Proposal for Amendment 1 to the Consolidated Resolution on the common specification of light source categories (R.E.5)

Submitted by the Working Party on Lighting and Light-Signalling*

Amendment 1 to the Consolidated Resolution on the common specification of light source categories (R.E.5)

Sheet H3/2, amend to read:

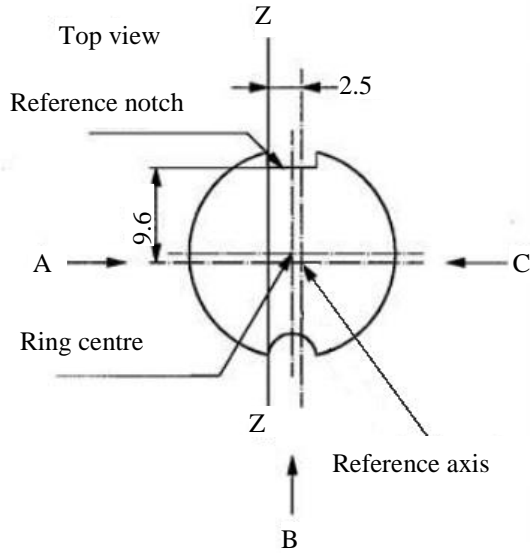
Definition: Ring centre and reference axis^{4/}

Sheet H11/2, top right drawing, amend to read:

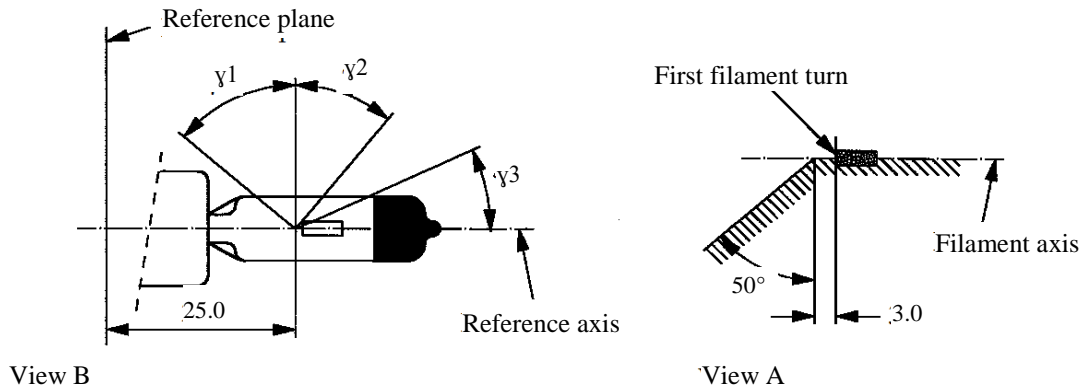
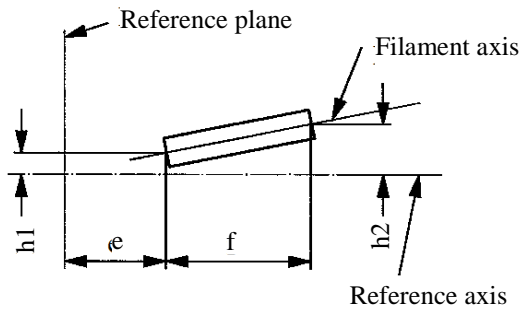
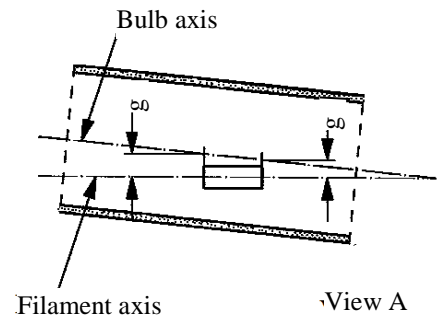
Figure 4 – Metal free zone⁸

Figure 5 – Permissible offset of filament axis⁹

Figure 6 – Bulb eccentricity¹⁰

Sheet H14/1, figure 1, amend to read:

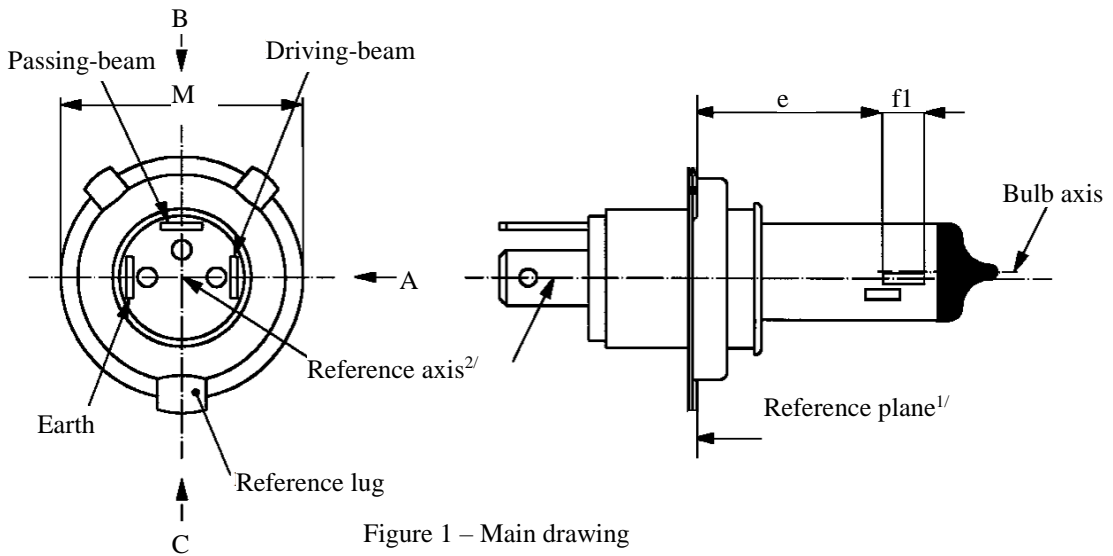
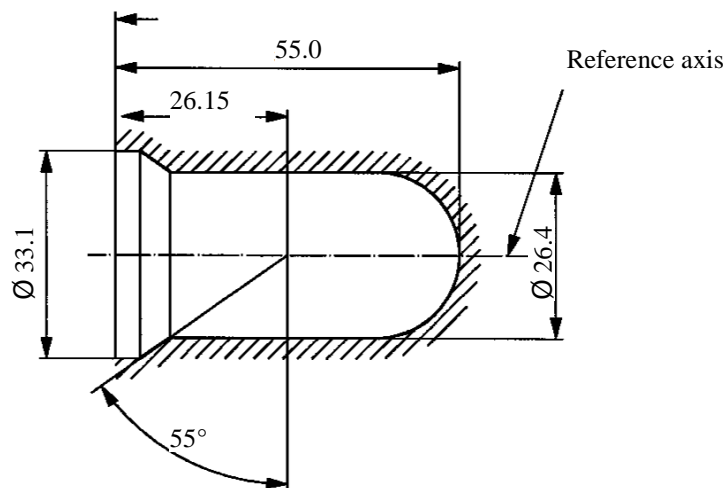
Figure 1 – Main drawing

Figure 2 – Maximum filament light source outline³/

Sheet P27/7W/3, amend to read:

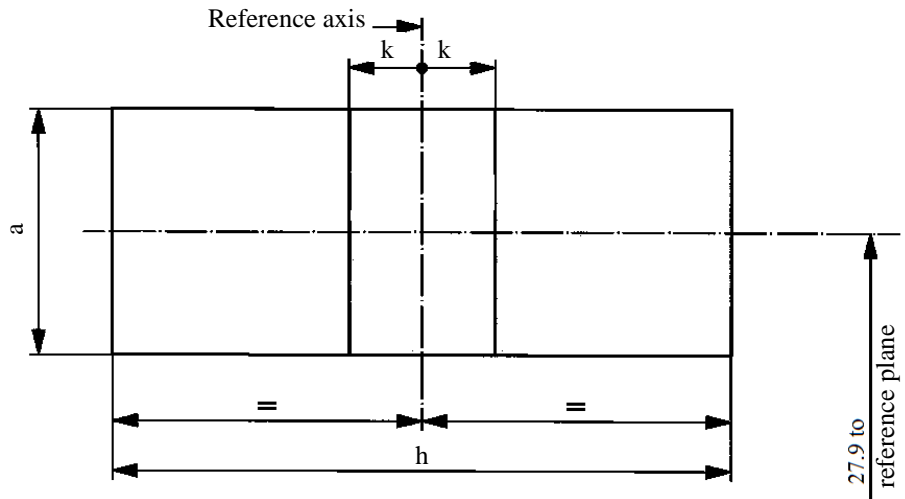
Side elevation

Front elevation
